# PRODUCT BULLETIN

# NO. 172

## THE MODEL 2260BC AND MODEL 2260C SERIES DISK DRIVES

FIGURE 1

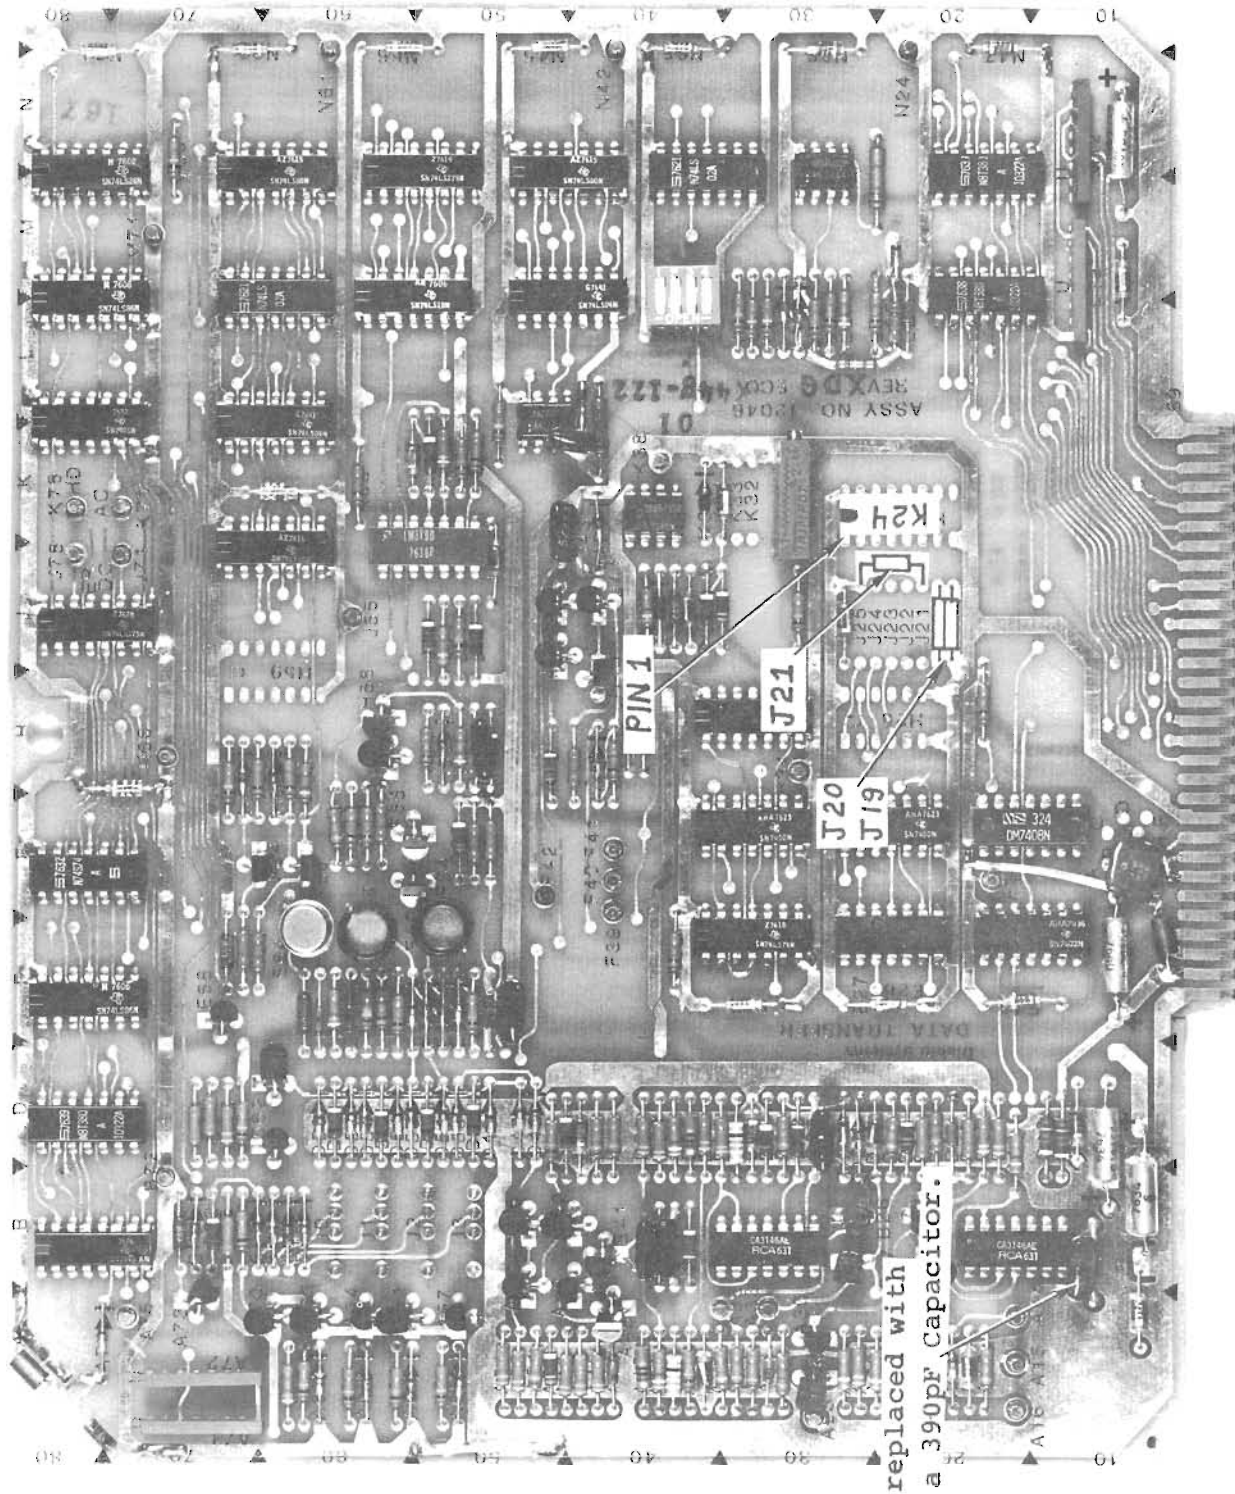
1. Remove Data Transfer PCB #12046-xx.
2. See Figure 1. Remove solder from K24, dip position holes.
3. Install a LM319, into K24 pins 1 to 7 and 10 to 16.
4. Install J19, 3.92K, 1/4 watt 1% resistor.
5. Install J20, 10K, 1/4 watt 1% resistor.
6. Install J21, .1uF, 50 V capacitor as shown.
7. Solder J19, J20, and J21 together on the side closest to K24. (On some PC Boards the three (3) points of J19, J20, and J21 may be already joined by runs.)
8. Install wire from J21, J26 junction, to K24-9.
9. Install wire from J19, J20, J21 junction to K24-10.
10. Install wire from K24-7 to K77-10.
11. Install wire form K24-8 to ground bus below K24.
12. Install wire from K24-6 to I/O pin 8. (see Figure 2)
13. Install wire from K24-11 to I/O pin 6.
14. Install wire from I/O pin 6 to J20, (closest to H25).

To improve Read Amplifier performance, the 470pF capacitor at location B11 should be replaced with a 390pF capacitor (see Figure 1).

FIGURE 2

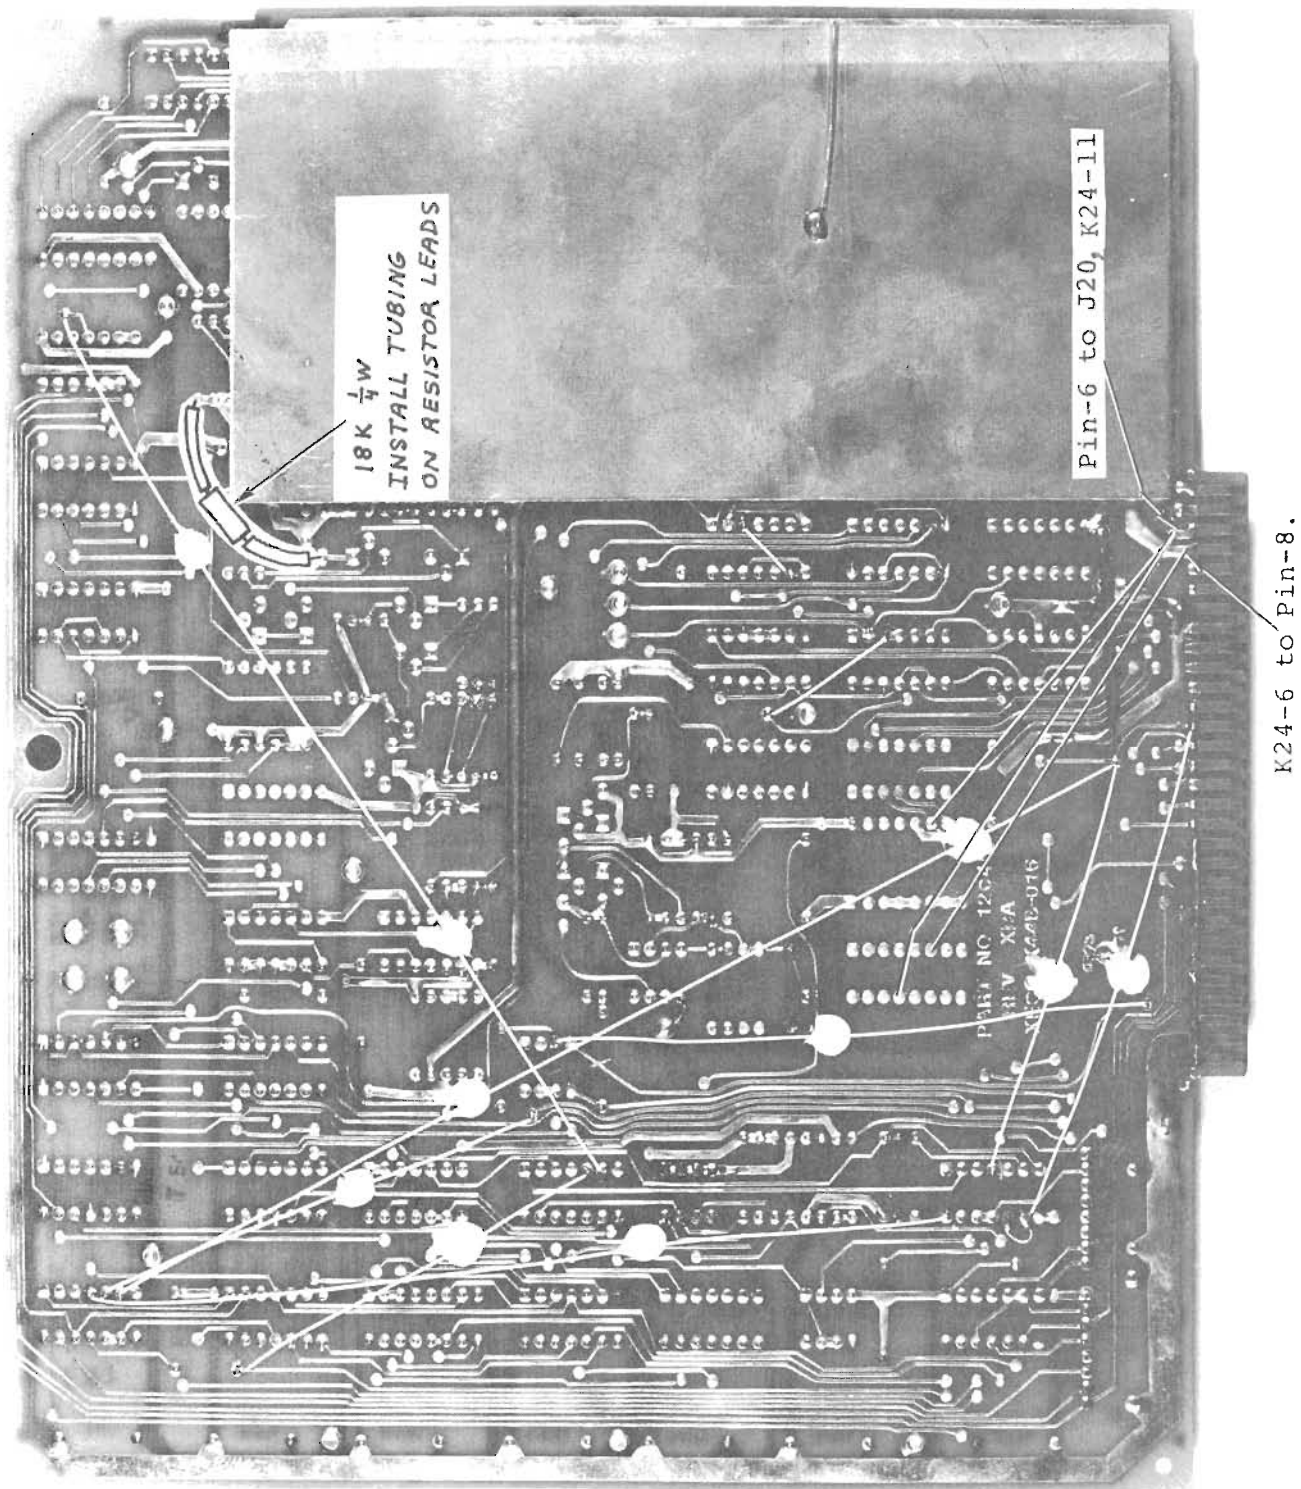
To increase the reliability of the 2N3725 write drivers, an 18K 1/4 watt resistor should be installed from the collector of E64 to -15V (see Figure 2).

FIGURE 7-7. DATA TRANSFER PCB SCHEMATIC - SHEET 1 #12046

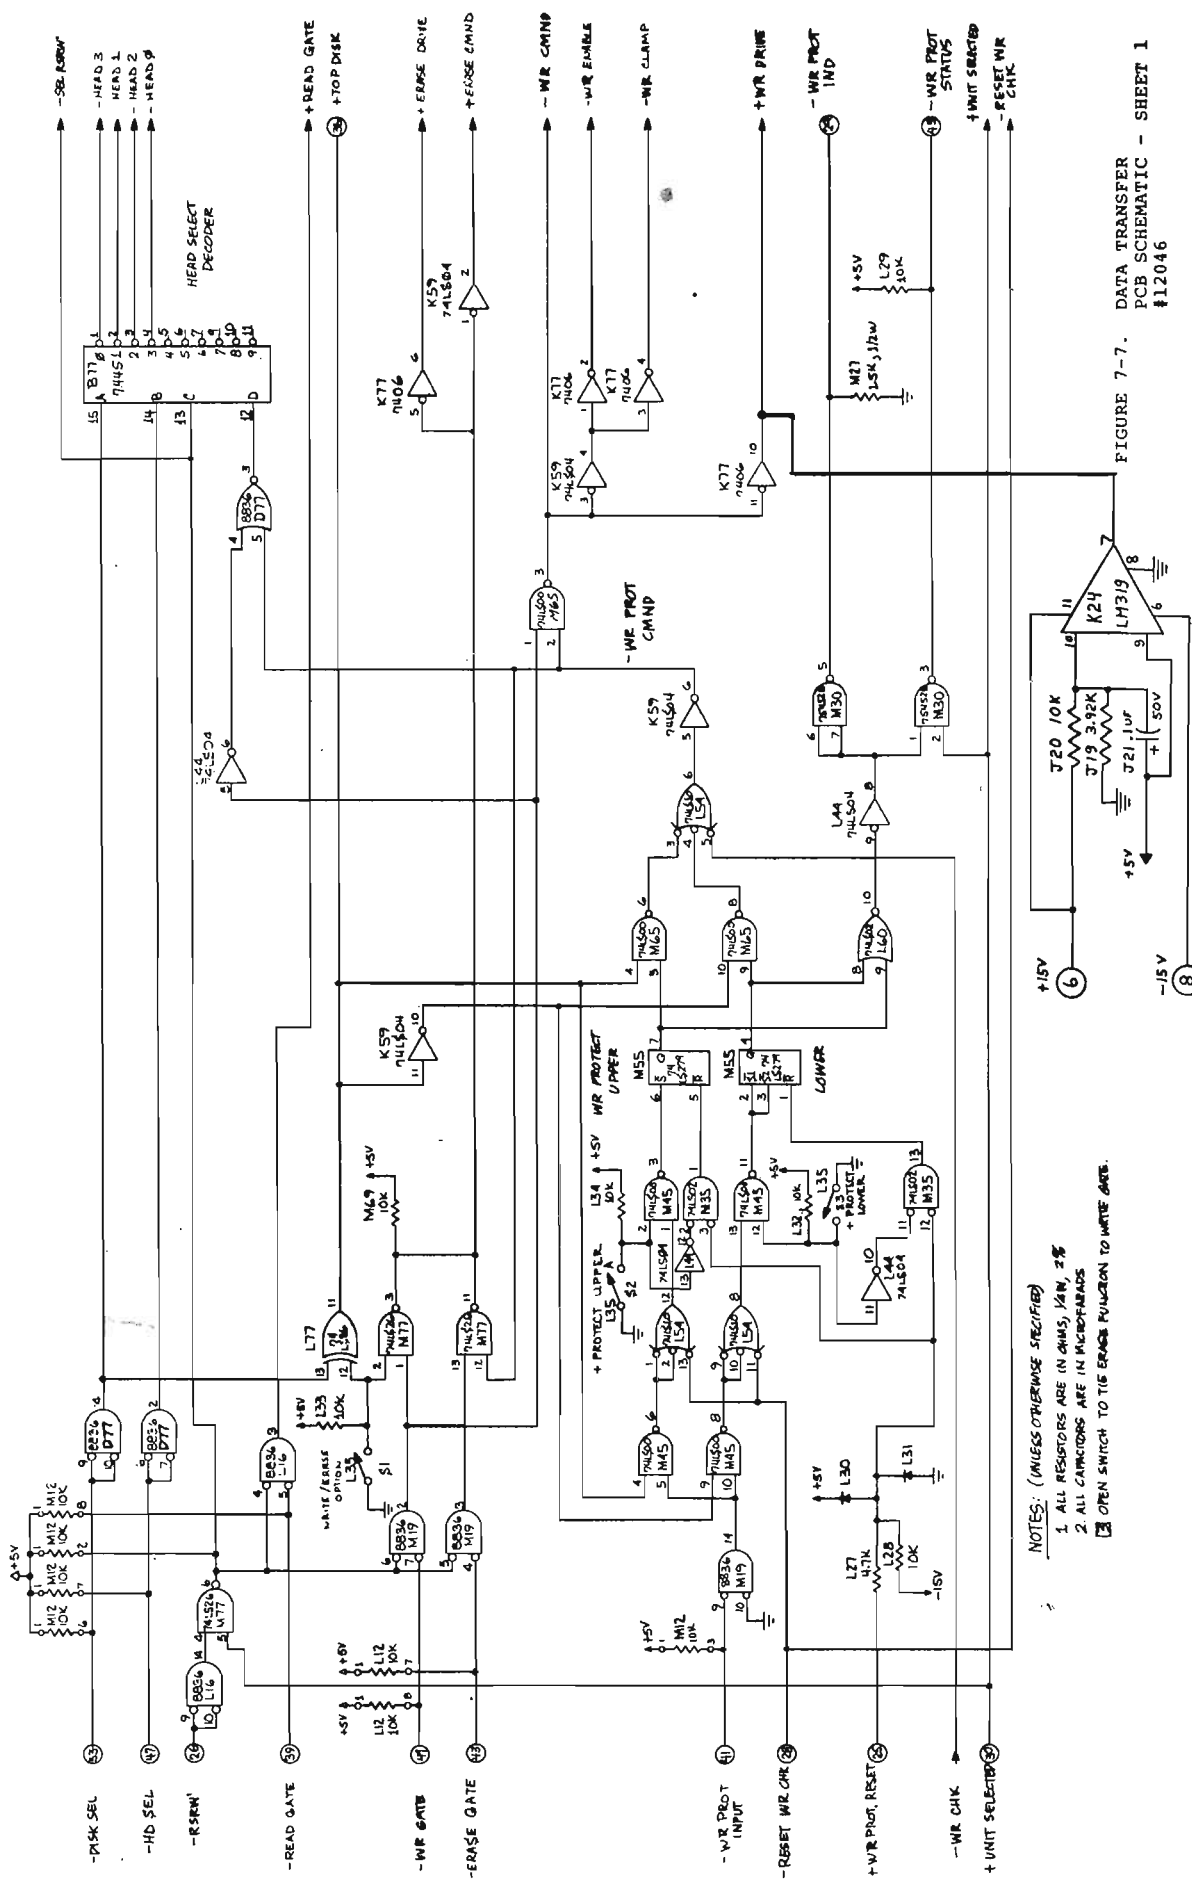
Update Data Transfer PCB Schematic sheet 1 (12046) according to Figure 7-7.

FIGURE 7-8. DATA TRANSFER PCB SCHEMATIC - SHEET 2 #12046

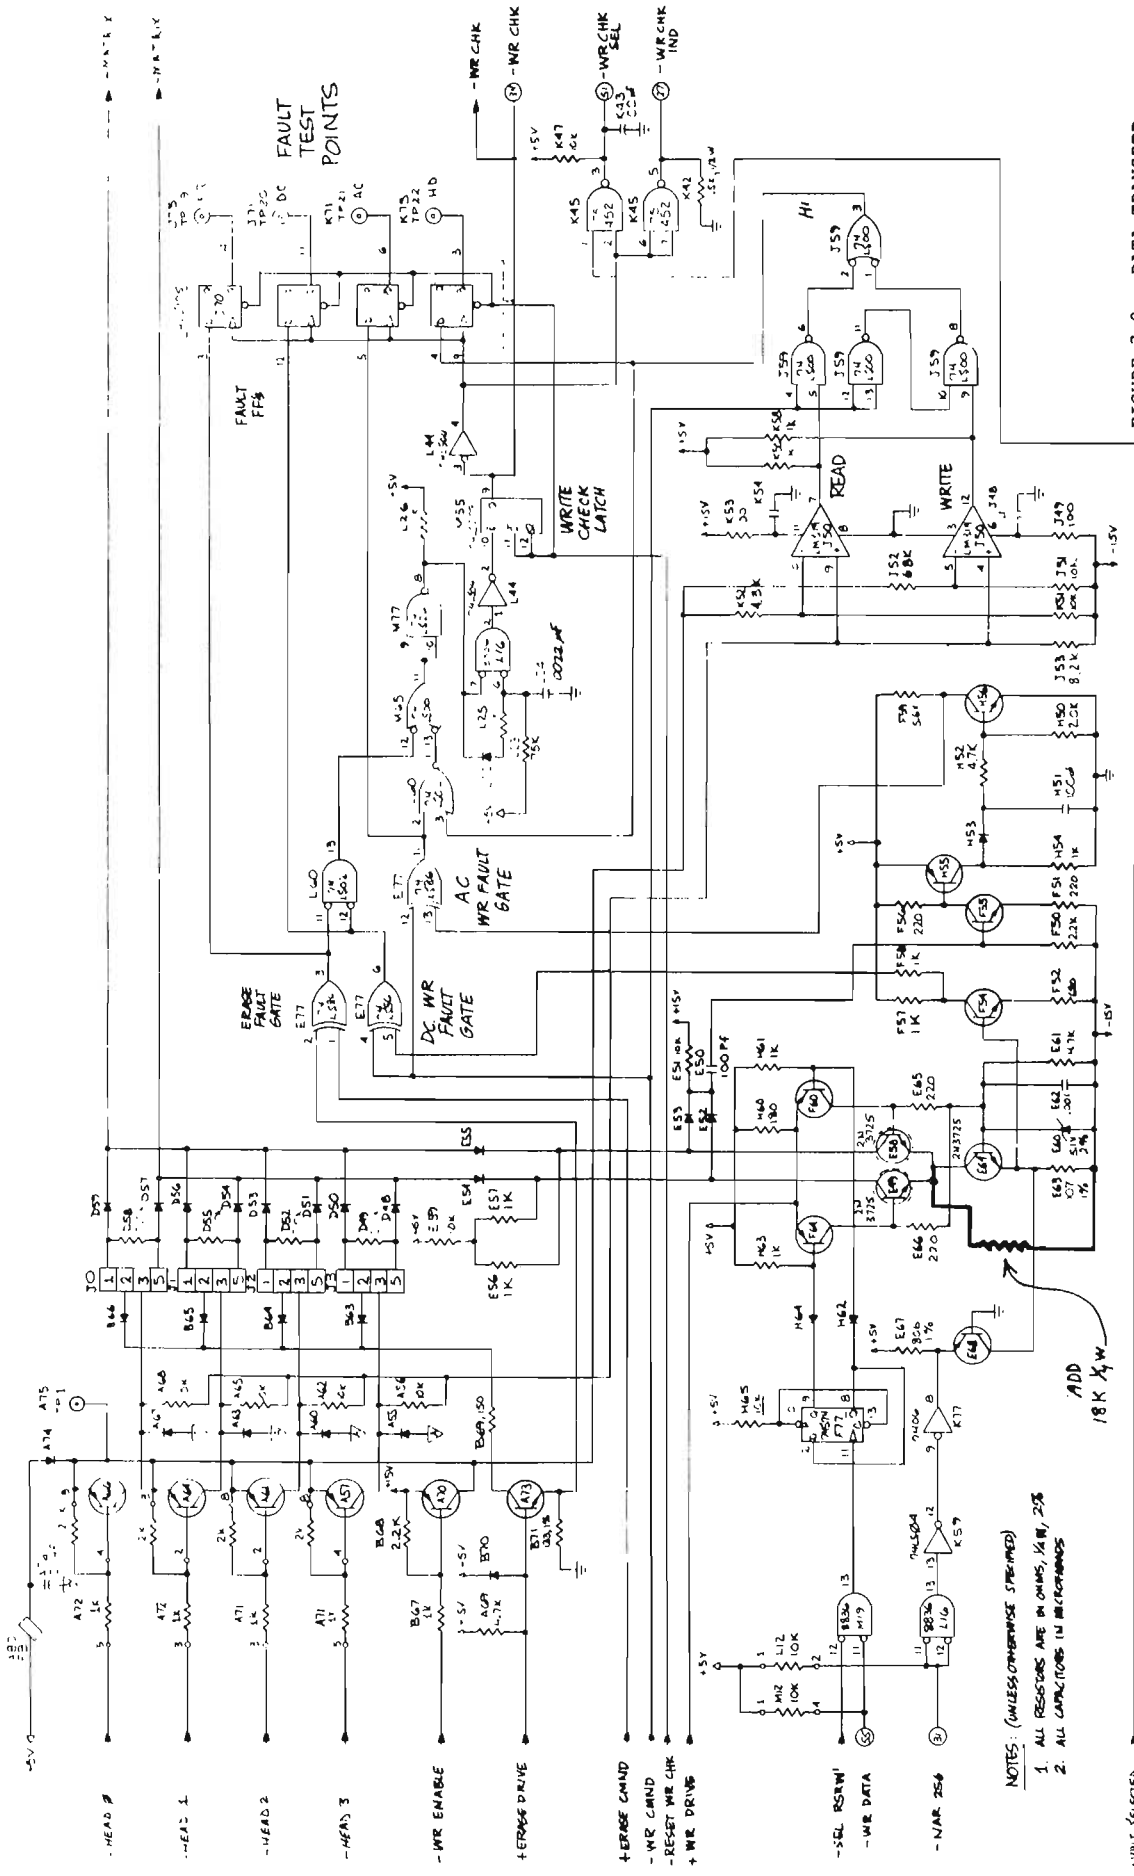
Update Data Transfer PCB Schematic sheet 2 (12046) according to Figure 7-8.

FIGURE 3  
7486 BOARD

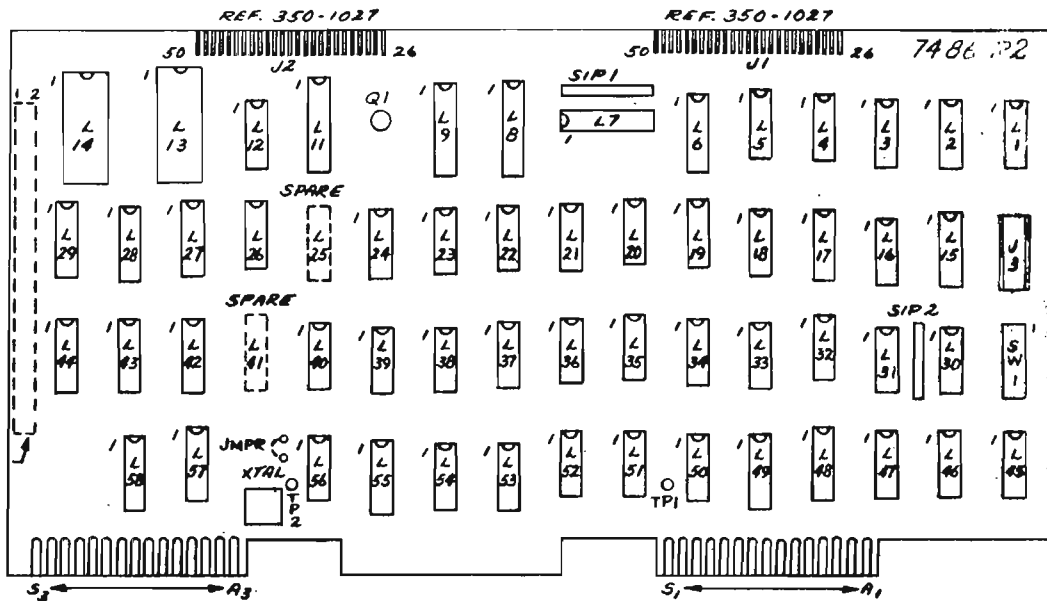
- 2) ECN #9462 - Change C1 from .01 uf. to .002 uf. (WL #300-1913). On R1 boards, this capacitor is located between L22 and L23; on R2 boards between L18 & L19. On the schematic diagram for the 7486 board, the capacitor can be found at coordinates 2F10 (Sheet 2, @ F10). Without this change, an intermittent error 61 (I92) may occur. This ECN changes the E REV from 1 to 2.

- 3) ECN #9628 - The cathode of diode D2 in the Write-Gate circuit should be attached to the junction of resistors R14 and R15, not the junction of resistors R15 and R17. Desolder and lift the cathode lead of D2 out, then connect it to the top of R14 (located next to D2). The top of R14 is connected to R15. (Ref: Figure 1)

Additionally, R10 (a 470-ohm resistor, located between L37 and L38) should be connected to + 0V, not +5VR. This resistor is part of the Clock Power-Up Clear circuit. (Ref: Figure 2).

4. ECN #9257 - Resistor R14 in the Write-Gate circuit should be 270 ohms, not 390 ohms. There is no E REV change associated with this ECN. (Ref: Figure 1)
